#### MATTHEW D. RUDIKOFF ASSOCIATES, INC.

> Re: CarMax Superstore; Tax Parcel #6156-02-664986 File Nos. 21-3439 and 22-4100

Graphic Juxtaposing Person Height and Lighting Fixture Height:

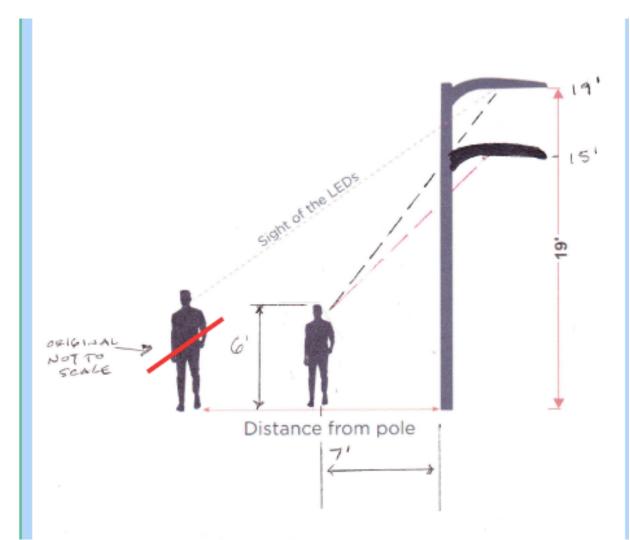
However, regarding proposed pole heights, it is noted that in the Applicant submitted materials is a graphic image depicting an average height person juxtaposed to various lighting fixtures which appears to be accidentally or purposefully distorted in its scaling of the person and the distance from the lighting fixture – which minimizes the appearance of the light fixture height. In the attached image at the end of this letter the figure depicting the person seems to be representing a 7' or 8' tall person making the light fixtures seem "less tall" and less like the highly industrialized storage yards perhaps more appropriate in large industrial parks or super shopping center developments. The depicted person must be scaled to the lighting fixture height.
